**ITEM 4 DEVELOPMENT APPLICATION: 19 WILLIAM STREET, ALEXANDRIA**

**FILE NO: D2005/00090**

**SUMMARY**

**Cross-Section of Proposed Development**

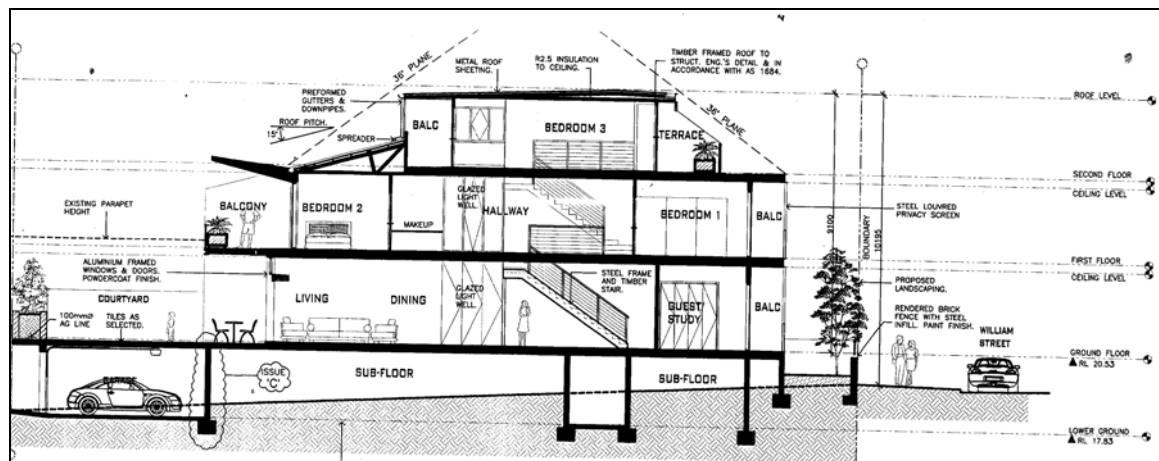
49. The DCP specifies a 9m height limit. The DCP also states *“In special circumstances Council may support a part storey above the prescribed height limit provided the part storey is wholly within the 36 degree Attic height plane....”*

50. In this instance, the proposed development, with an uppermost ceiling height of 10.6m, complies with the DCP in that the uppermost floor is a “part storey” with the building mass contained within the 36 degree roof envelope.
51. It is considered the “special” circumstances that support the part storey above the prescribed height limit, is that the part storey is within the attic level, is directly connected to the floor below and will present as a 2 storey dwelling to the street (refer to diagram below).

53. The failure to provide a minimum 2.7m ceiling height for the habitable rooms on the second floor is unacceptable. Accordingly, given the “generous” ceiling heights proposed for non-habitable uses on the lower ground floor, it is recommended that some of this “height” be transferred to the second floor whilst not increasing the external building envelope. An appropriate deferred commencement condition has been included in the recommendation.

- (2) The design of the building shall be modified to ensure that a minimum floor to ceiling height of 2.7 metres is provided to all habitable rooms on the ground, first and second floors. In modifying the building design, the overall building envelope shall not be enlarged.
